LILA'S PLACE SUBDIVISION

APPLICATION NUMBER 7 DATE September 2, 2021

REQUEST Subdivision

DETAIL SITE PLAN

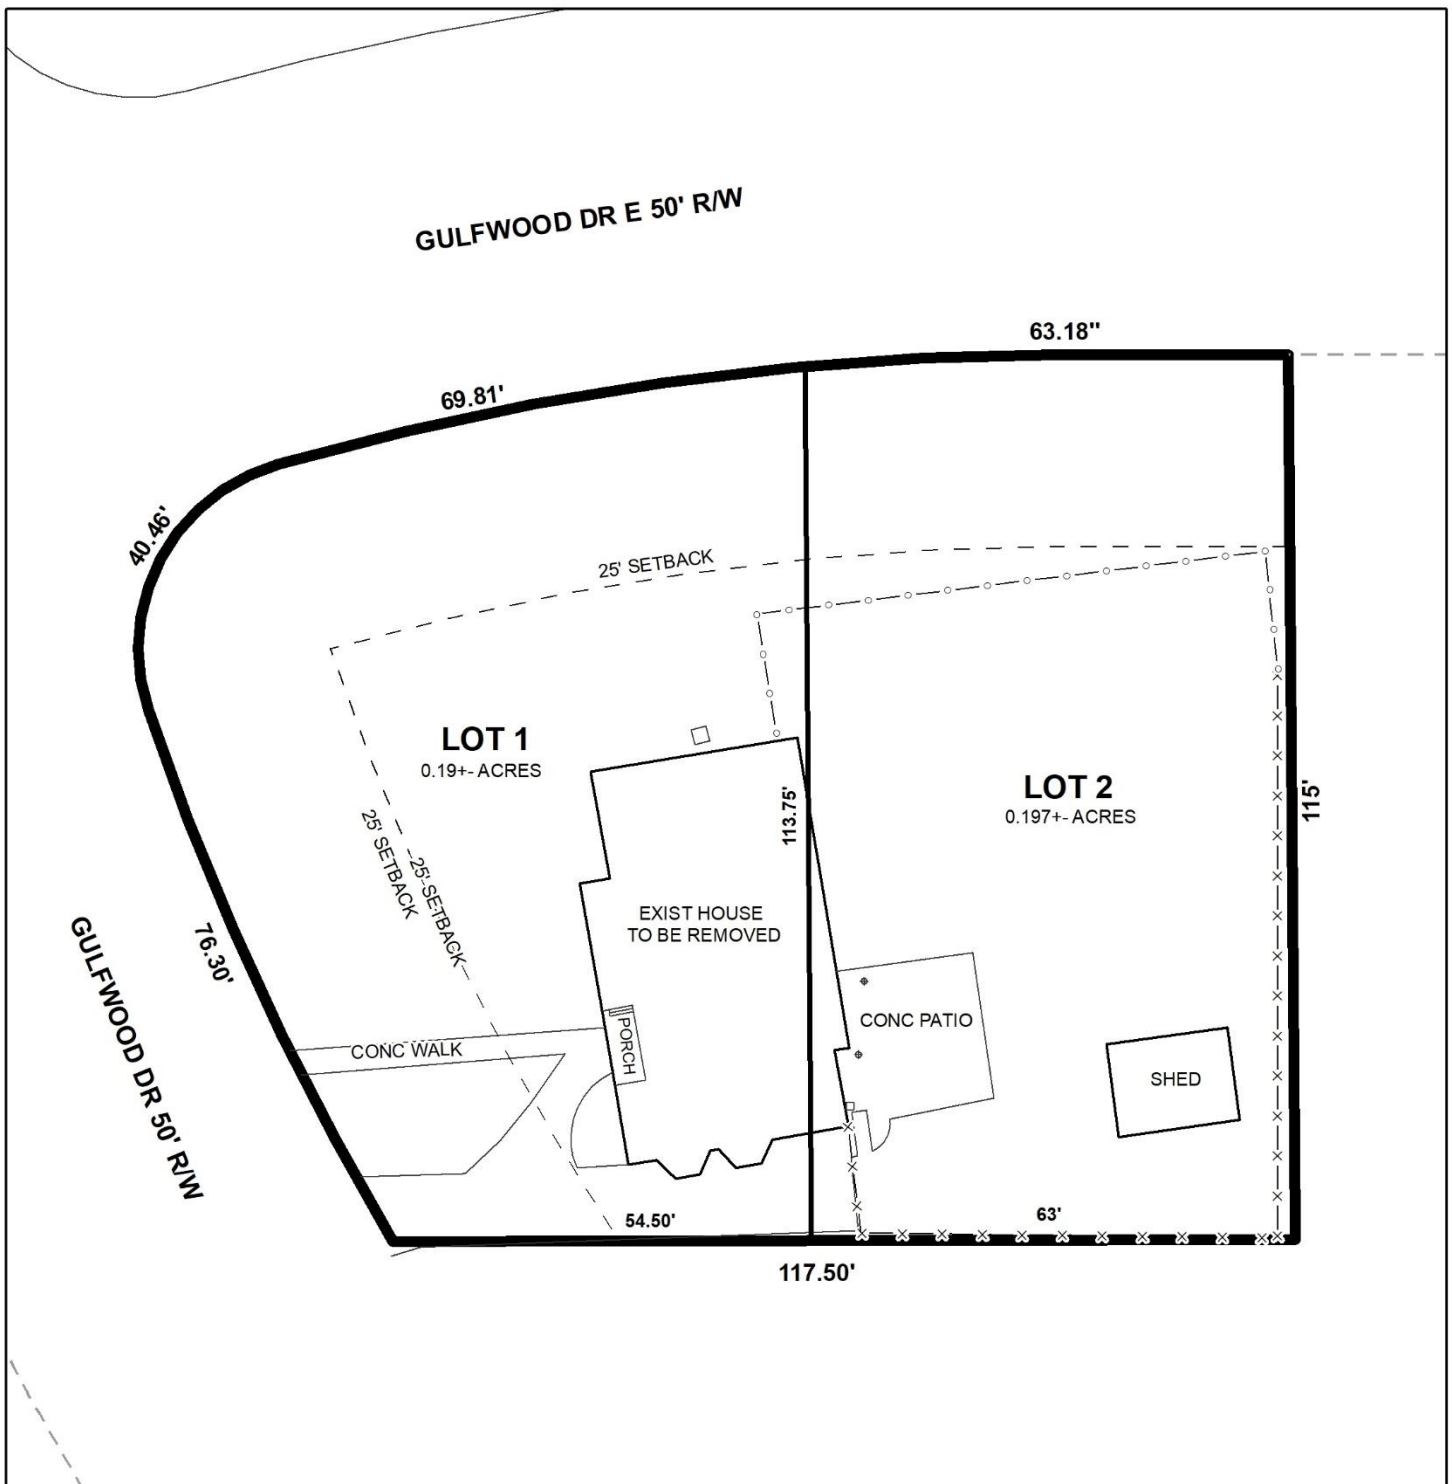
The site has frontage on Gulfwood Drive and Gulfwood Drive East, both minor streets without curb and gutter and 50-foot rights-of-way. Typically, streets without curb and gutter require a 60-foot right-of-way, but as this site was originally approved by the Planning Commission and recorded with 50-foot rights-of-way, a waiver of Section V.B.14. of the Subdivision Regulations may be appropriate. The site has compliant 25-foot radius curve at the intersection; therefore, no dedication would be required. As on the preliminary plat, the right-of-way widths of both streets should be retained on the Final Plat, if approved.

As on the preliminary plat, the 25-foot minimum building setback line should be retained on the Final Plat. The proposed lot meets the minimum size requirements of the Subdivision Regulations. As on the preliminary plat, the lot size label in both square feet and acres should be retained on the Final Plat, or a table should be furnished on the Final Plat providing the same information.

The preliminary plat shows an existing house and shed on the property, with the house straddling the proposed lot line. The house is labeled as “to be removed”. It should be noted that prior to

the signing of the Final Plat, demolition permits should be obtained for the removal of both the house and shed, if approved.

- 1) retention of the right-of-way widths of both streets on the Final Plat;
- 2) retention of the 25' minimum building setback line along both street frontages on the Final Plat;

- 3) retention of the lot size label in both square feet and acres on the Final Plat, or the furnishing of a table on the Final Plat providing the same information;

- 4) obtaining demolition permits for both the existing house and shed prior to the signing of the Final Plat;
- 5) compliance with the Engineering comments: (*FINAL PLAT COMMENTS (should be addressed prior to submitting the FINAL PLAT for review and/or signature by the City Engineer): A. Provide all of the required information on the SUBDIVISION PLAT (i.e. signature blocks, signatures, certification statements, written legal description, required notes, legend, scale, bearings and distances) that is required by the current Alabama State Board of Licensure for Professional Engineers and Land Surveyors. B. Provide the Surveyor's and Owner's (notarized) signatures. C. Add a note – "As shown on the 1984 aerial photo (FLIGHT 24 - #73) LOTS 1 and 2 will receive historical credit of existing (1984) impervious area towards stormwater detention requirement per Mobile City Code, Chapter 17, Storm Water Management and Flood Control) as follows: LOT 1 – 1,700 sf and LOT 2 – NONE. D. Email a pdf copy of the FINAL SUBDIVISION PLAT and LETTER OF DECISION to the Permitting Engineering Dept. for review at land.disturbance@cityofmobile.org prior to obtaining any signatures. No signatures are required on the drawing. E. After addressing all of the FINAL SUBDIVISION PLAT review comments provide the ORIGINAL (with all signatures except for the Planning Commission, Traffic Engineering, and City Engineer), one (1) copy, and a transmittal letter to the Engineering Permitting Department. They can be dropped off at 205 Government St. or mailed to PO Box 1827, Mobile, AL, 36633.*);
